Product Change Notification

Product Change Notification: PCN-24-201503

Product Description: (Text limited to 120 characters)
Platinum thin film temperature sensors on ceramics substrate

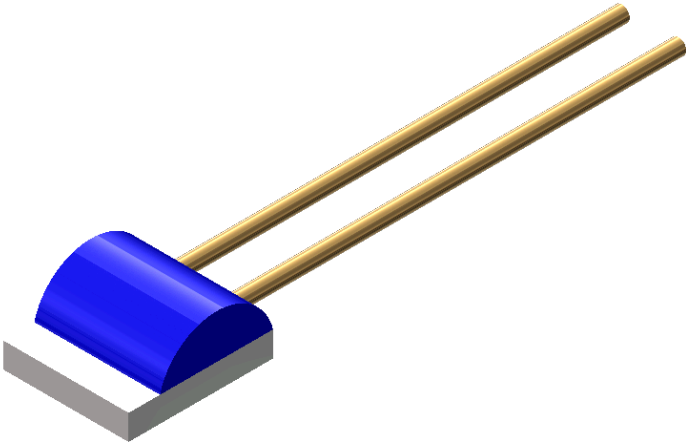
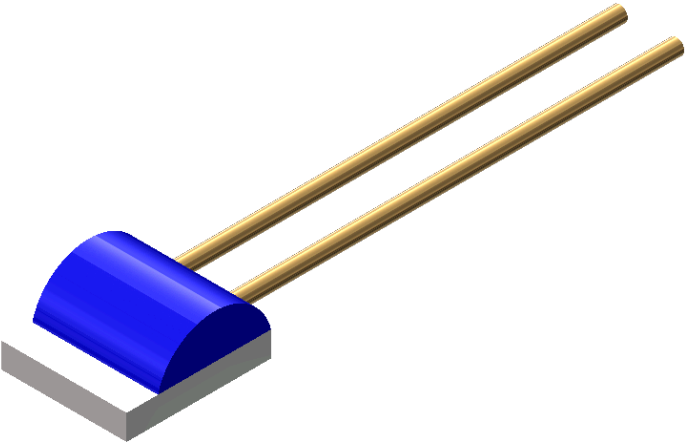
General Description of Changes
Change blue fixation material to lead free composition. Slightly change of blue color can occur compared to the current state.

<p>Composition of blue wire fixation material contents some lead. This is currently covered by an exceptional permission.</p> 	<p>New fixation material is lead free now and complies to RoHS. No exceptional permission needed.</p> 
--	---
